BRINJAC, KAMBIC AND ASSOCIATES, INC.
REVIEWED DATE: 3/24/98
BY: LMO

JOB NAME: 6TH AND DUNCANNON

TITLE: PARTIAL 3RD FLOOR HVAC PIPING

DRAWING NO. H-12

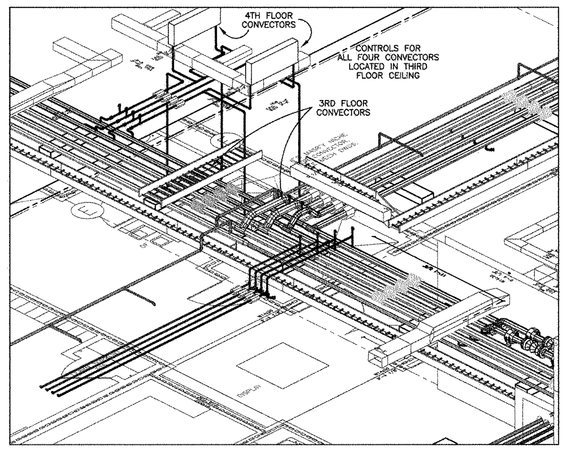
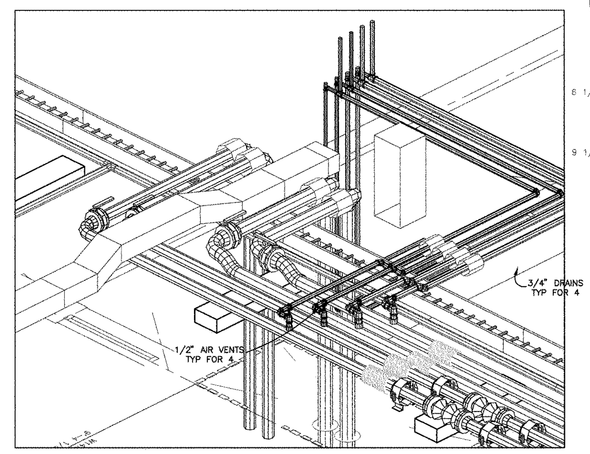
NOTES FROM MTG. 10/23/96

CEILING HT. 8'-4"
LIGHTS IN CORRIDOR SURFACE MTD.
SOFFIT @ DRAINS
CABLE TRAY MAY RUN @ CLG.
ASK SHARON TO CHANGE DUCT AS SHOWN

THE SUBMITTALS FOR THE UNIT VENTILATORS INDICATE THE CASEWORK TO BE 22" DEEP.
